INNER WEST COUNCIL

DEVELOPMENT ASSESSMENT REPORT

Application No.	DA201600108.01
Address	308-314 Stanmore Road Petersham
Proposal	To modify Determination No. 201600108 dated 29 September 2016 under Section 4.55 of the Environmental Planning and Assessment Act so as to modify the internal layout to increase the total number of hotel rooms from 12 to 21 rooms, alter the location of the florist and food and drink premises and carry out other internal modifications
Date of Lodgement	9 July 2018
Applicant	Preston Peterson
Owner	T Nguyen & V Tran
Number of Submissions	10 submissions
Value of works	\$2,000,000
Reason for determination at Planning Panel	Heritage Item; Breach to development standard; Number of submissions
Main Issues	Heritage; Parking
Recommendation	Consent subject to conditions
Attachment A	Recommended modified conditions of consent
Attachment B	Plans of proposed development
Attachment C	Officer's Report for DA201600108
Attachment D	Stamped Plans of DA201800108

Image 3: Extract of Second Floor Plan original submitted showing extension of second floor (highlighted in blue)

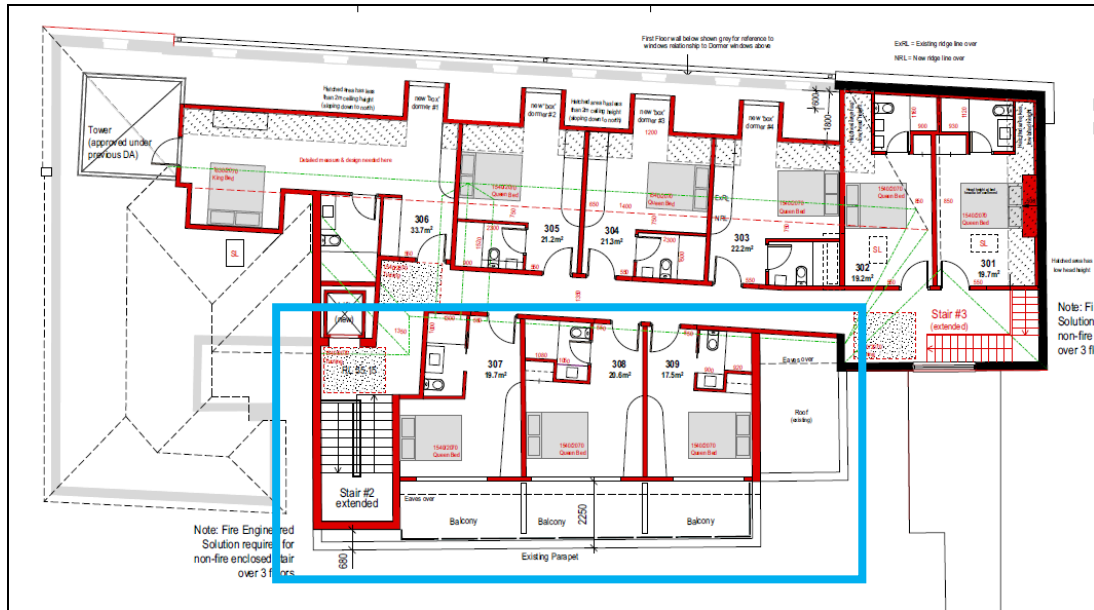
However, during the assessment process Council raised concerns with the proposed increase to the second floor due to the increased visibility of the addition, the impacts to the heritage item and further increase to the FSR at the site. As such, final amended plans were submitted on 17 January 2019 removing the proposed increase to the second floor and maintaining the approved building envelope. This also resulted in the number of rooms being reduced to 21.

Image 4: Extract of final Second Floor Plan with the rear balcony retained

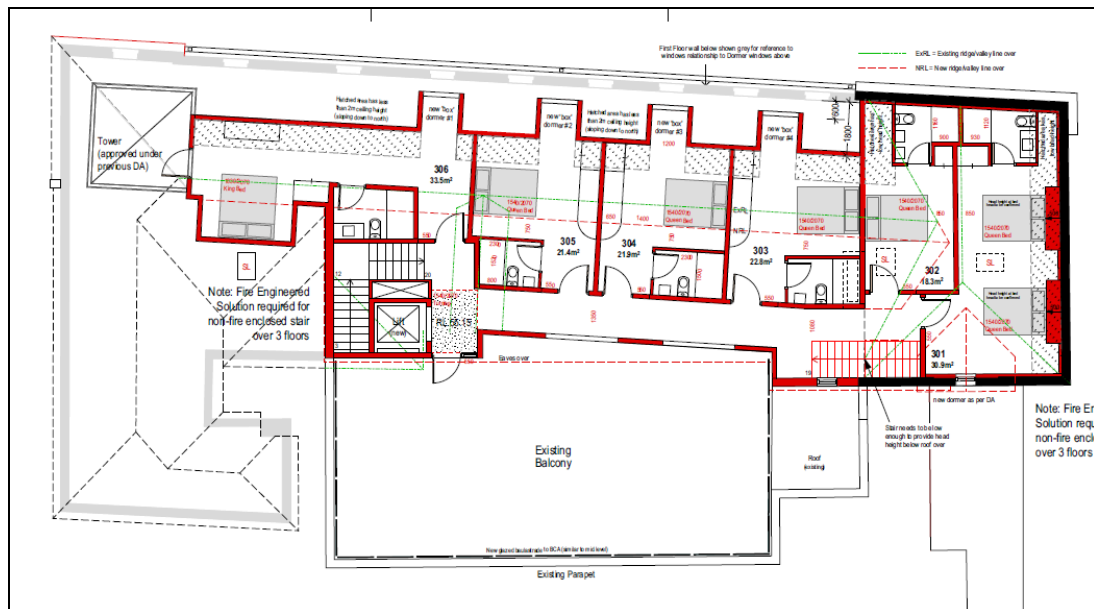
As such, the description of the application was amended accordingly to reflect the retention of the approved second floor and a reduction in room numbers proposed. The amended plans submitted on 17 January 2019 and the subject of the assessment report and are included at **Attachment B**.

As such, a modification to Condition 10 is included in Attachment A to remove reference to room 12 and ensure the condition limits the use of the second floor balcony.
